RE: Project No. 12611-003 – New York, Roosevelt Island Tidal Energy Project
Request for Additional Information on Draft Pilot License Application

ROOSEVELT ISLAND TIDAL ENERGY PROJECT
P-12611-003

**VERDANT POWER RESPONSE TO
REQUEST FOR ADDITIONAL INFORMATION ON
DRAFT PILOT LICENSE APPLICATION**

Figure 2.3-a. Bird monitoring viewshed

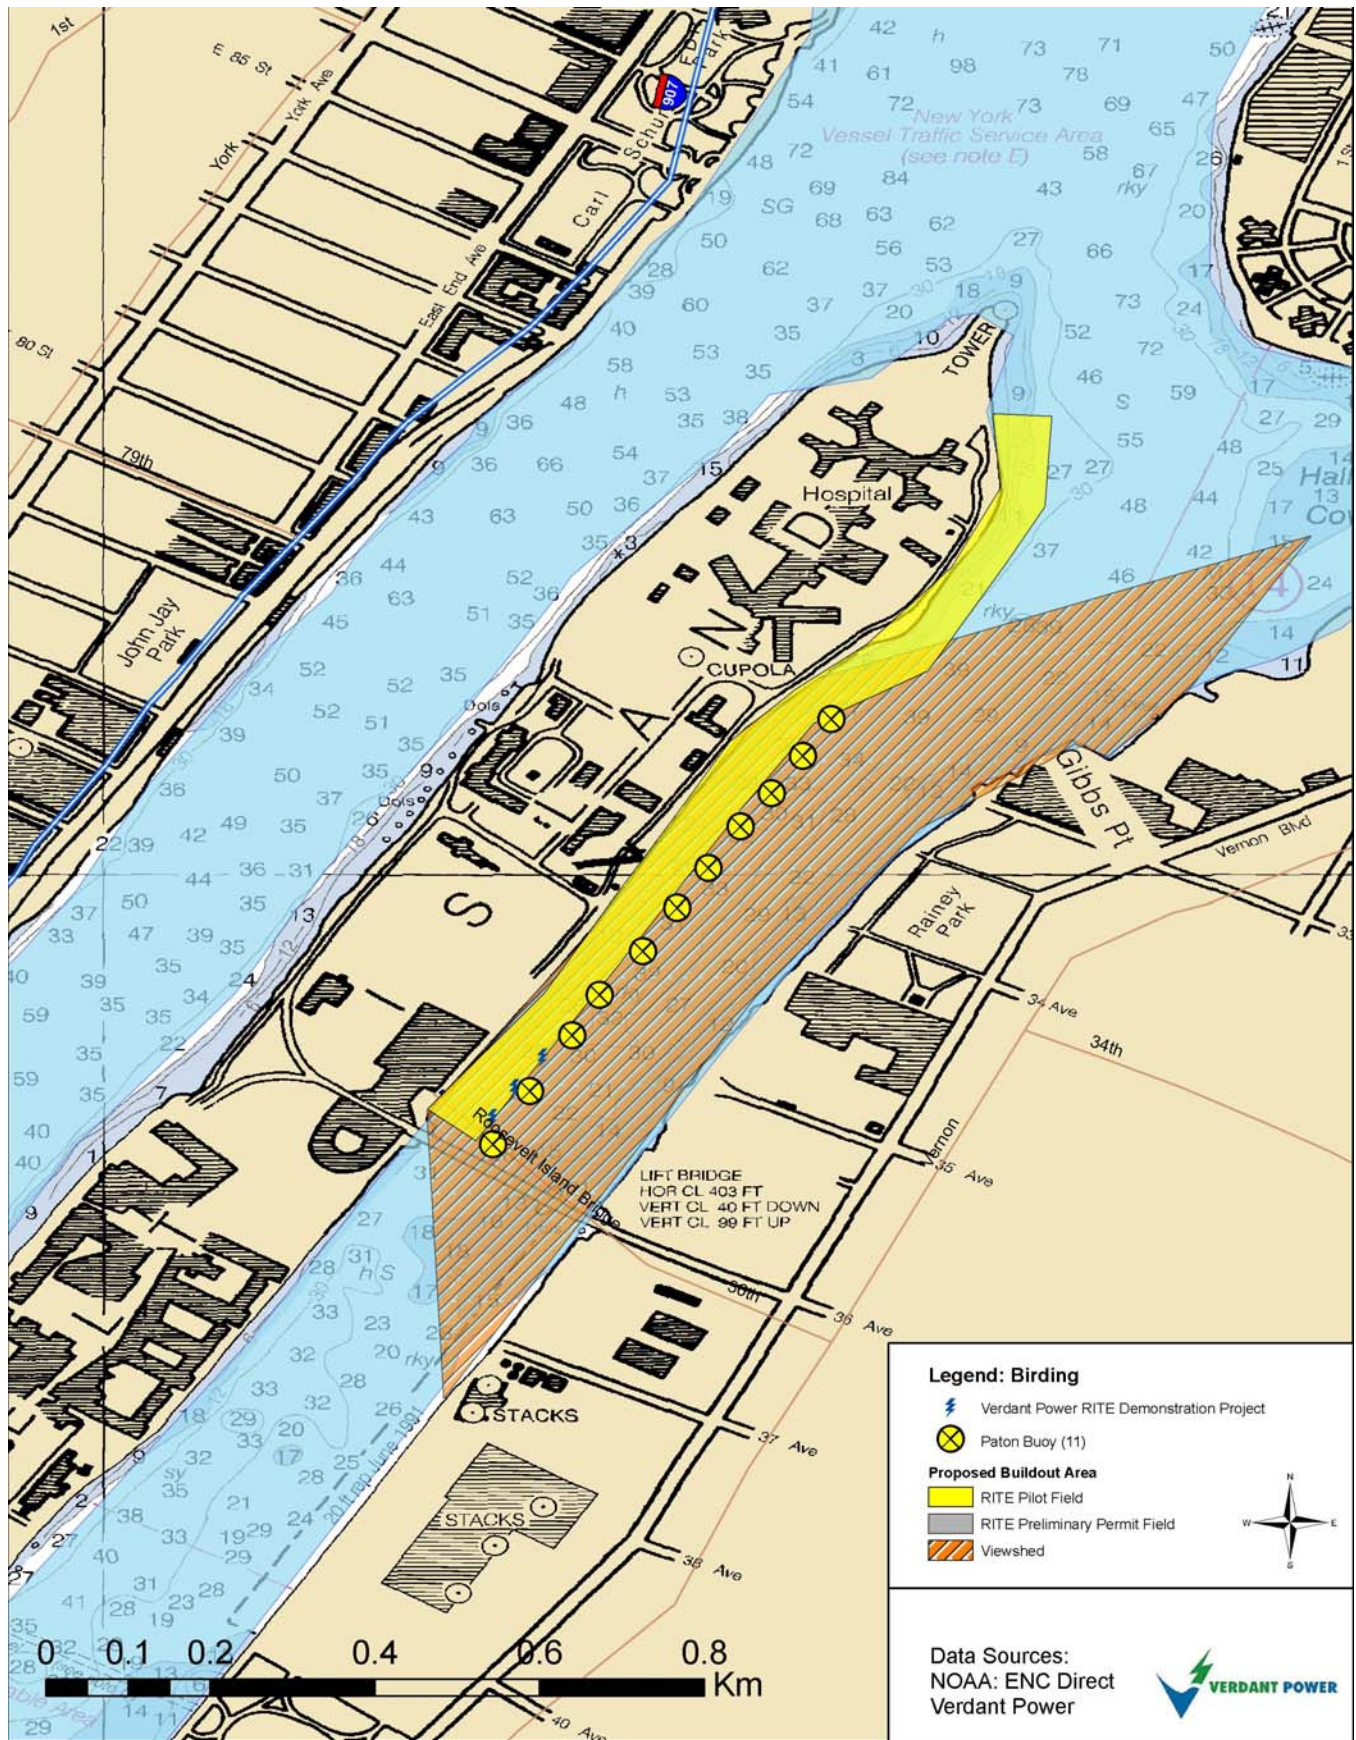
13(b). Figure 5.3.4.1-2 on page E-136 showing the bird observation study viewshed, only covers the southern ¼ portion of the project boundary. Bird observations should be conducted for the entire area within the project boundary. The bird monitoring plan has no discussion of proposed locations for future bird observations. Please revise the bird monitoring plan to include locations and methods for monitoring the entire project boundary within the observation area.

As noted on page 18 of Verdant Proposed Monitoring Plans, it is proposed that two birders will likely be needed to cover the full 30 KHPS turbine field. One birder will be stationed at the “bulge” of Roosevelt Island and one birder will be stationed at the southern end of the turbine field. This would allow complete coverage of the project area. The Figure 2.3-a shows the viewshed that will be covered by birding during the RITE Project. Figure 2.3-a can be found in Appendix B.

Exhibit G-1A sketch

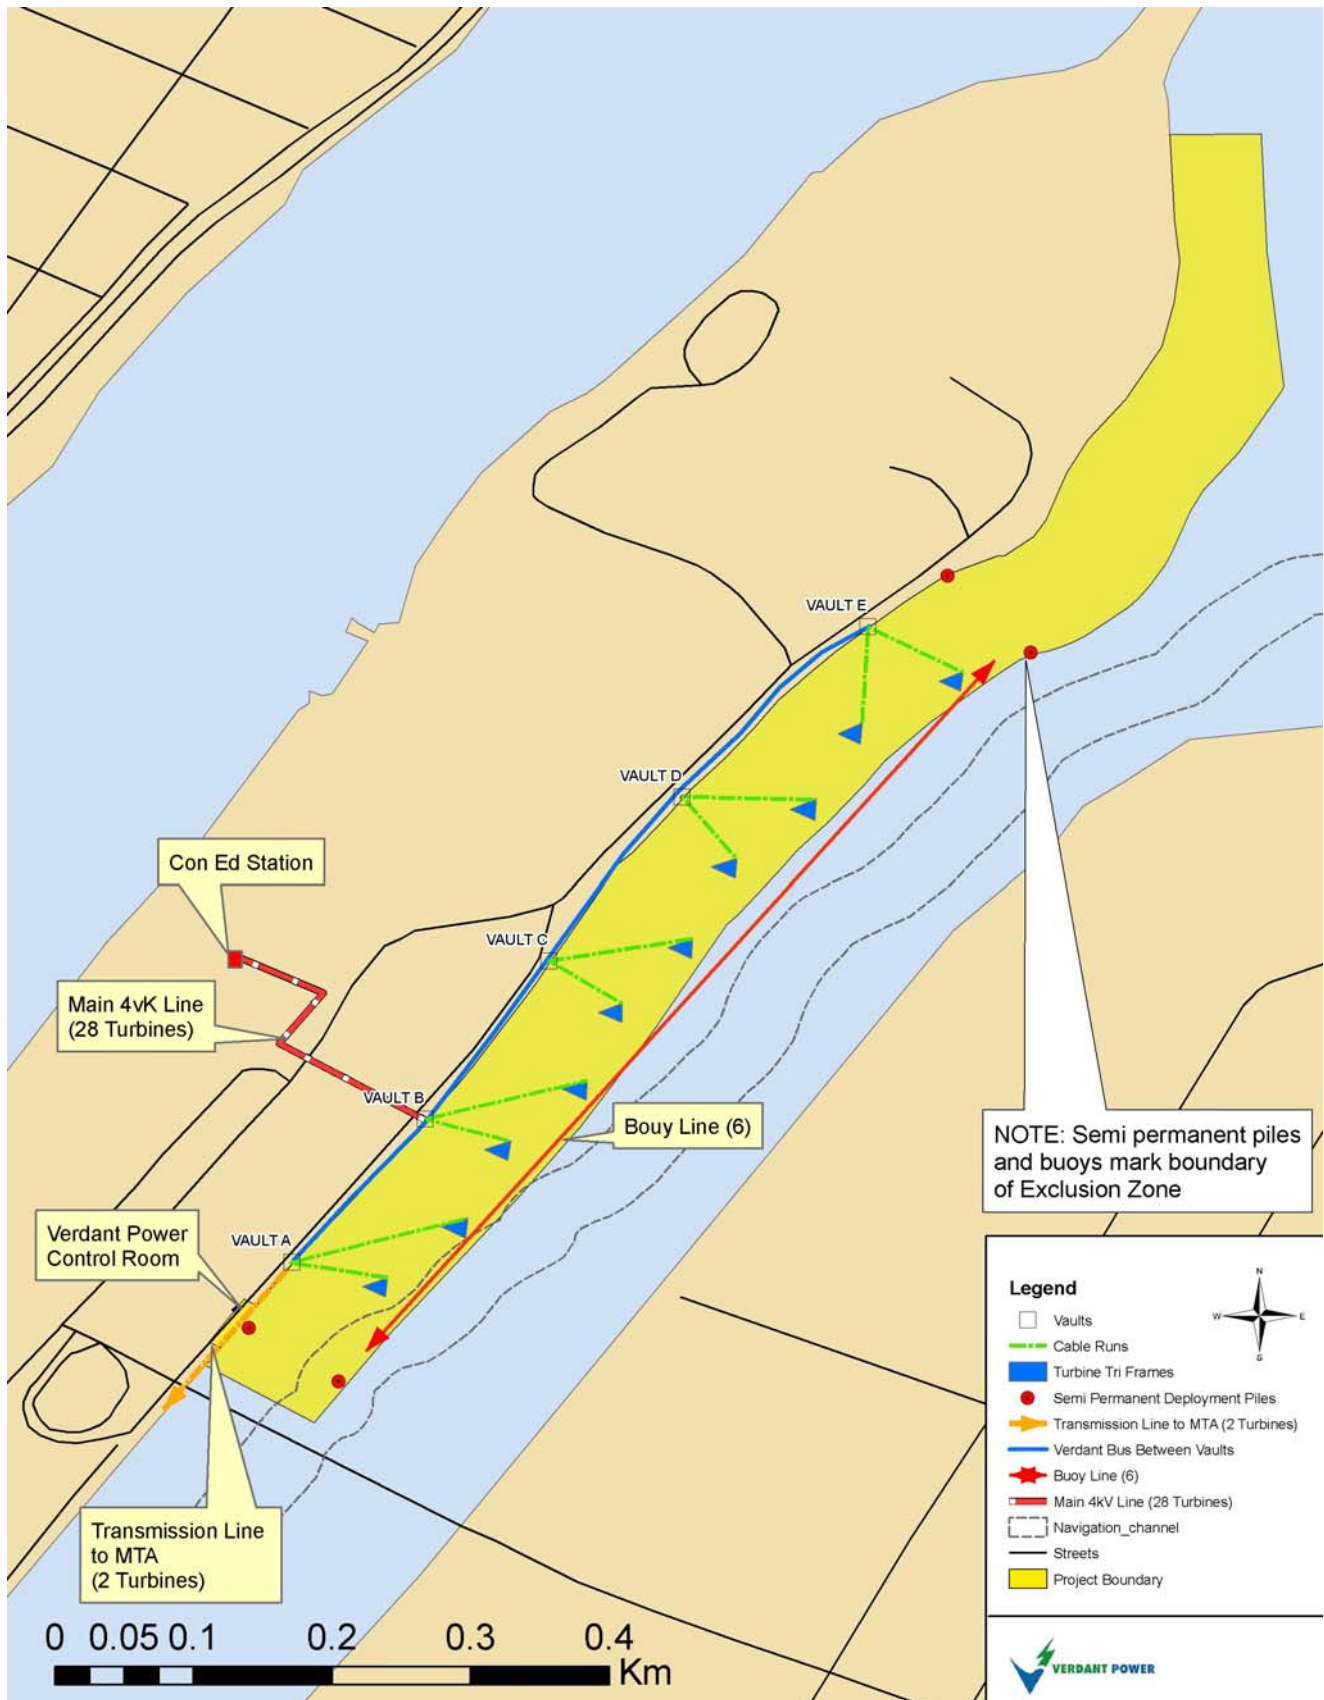
16. The exhibit G drawing shows the location of proposed project facilities including 10 tri-frames, 5 shoreline switchgear vaults, and the control room enclosed within a project boundary. The exhibit G also labels three New York State Plane reference points. However, the exhibit G drawing does not show and label: (1) all project underwater electrical cables connecting the tri-frames with the switchgear vaults; (2) transmission line(s) to the point of interconnection with the regional grid within the project boundary; and (3) be stamped by a registered land surveyor.

This sketch supplements the Exhibit G. Verdant will provide a revised Exhibit G with the filing of the Final License Application. A stamped registered land survey will be conducted as part of the post license requirements .
